Decision Document GAMBELL FORMERLY USED DEFENSE SITE F10AK0696

St. Lawrence Island, Alaska

June 2005

Proposed Plan for Remedial Action, Gambell FUDS, St. Lawrence Island, Alaska July 2004

Figure 6 - Site 12 vicinity map

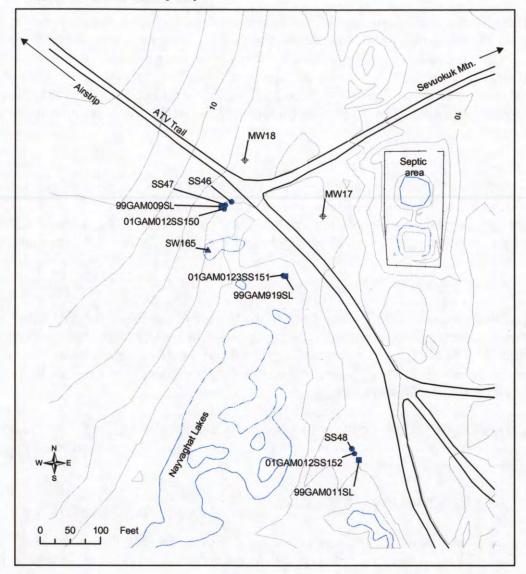
Site 12, p 26. I support the proposed alternative to remove sources of heavy metal contamination. Additional sampling should be done to delineate the full extent of contamination.

Confirmation samples will be collected after the soil is excavated, to verify the contamination was adequately removed.

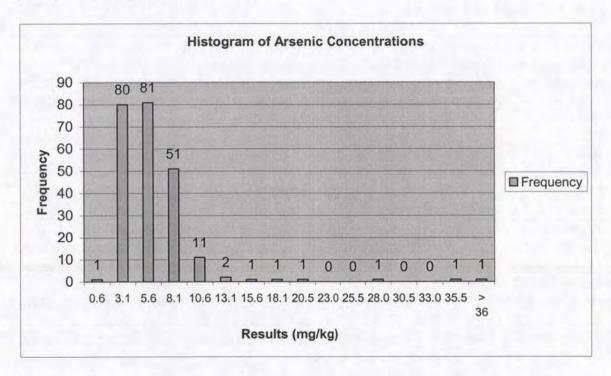
Throughout the document, arsenic levels are considered "attributable to background" and not of military source. In some cases, arsenic levels are averaged and no further action is justified based on an average concentration. This is inappropriate and unjustified. True background levels are not provided. Often arsenic levels exceed ADEC cleanup standards. These sites should be remediated so that arsenic levels are below ADEC cleanup standards.

It is appropriate to use average concentrations of arsenic on a site-specific basis. The U.S. Environmental Protection Agency (US EPA) recommends calculating a reasonable maximum exposure (RME) for residential scenarios. Thus, the RME for chronic exposure on a site-specific basis is estimated using an average concentration of a chemical of concern. Average concentrations are typically derived by statistical methods by calculating the 95% Upper Confidence Level on the arithmetic mean of a dataset. U.S. EPA's Soil Screening Guidance Fact Sheet (July 1996) states that "For data sets of lesser quality, the 95% upper confidence level on the arithmetic mean of contaminant soil concentrations can be compared directly to the SSLs [soil screening levels]. The TBD [Soil Screening Guidance: Technical Background Document (U.S. EPA 1996)] discusses strengths and weaknesses of different calculations of the mean and when they are appropriate for making screening decisions."

A statistical evaluation of the entire dataset (232 data points) of arsenic concentrations (excluding all non-detects) in Gambell demonstrates that 96.6% of the data falls below 10.6 ppm and 97.4% of the data fall below 13.1 ppm. This dataset includes locations which have been subsequently removed during remedial actions at the site (e.g., the sample result of 38 ppm at Site 4B from 1994), or are planned for removal (e.g., confirmation sampling results from Site 7 in 2003 of 27.9 and 34.9 ppm). A histogram of the data distribution is shown below, with the number of samples in each evenly spaced "bin" (i.e., an equally spaced interval) shown. The average arsenic concentration is 5.0 mg/kg, with a standard deviation of 4.2, and a 95% upper confidence level of 6.2 mg/kg (Chebyshev, non-parametric method).
